SUBJECT: KINGSTON STEAM PLANT - ANNUAL ASH DISPOSAL AREA INSPECTION

SUBJECT: KINGSTON STEAM PLANT - ANNUAL ASH DISPOSAL AREA INSPECTION

#### KINGSTON STEAM PLANT - ANNUAL ASH DISPOSAL AREA INSPECTION

DISCHARGE / OUTLET NOTE:
 VEGETATION.

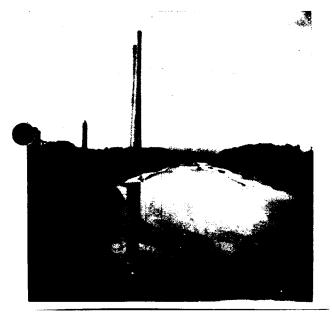
The vegetation at the base of the discharge end wall appeared to be excessive (see picture number 4 and recommendation number 4).

- 1. Plant personnel should continue to monitor the seepage at the toe of the exterior slope of the sound end of dike "C". Should contact F&H PR, Chattanooga, and EN DES immediately if any changing conditions are observed.
- 2. Should remove all small trees and brush from exterior slope of dike
- 3. Should remove any vegetation within the spillway/skimmers.
- 4. Should remove the weeping willow trees and vegetation at and around the base of the discharge end wall.
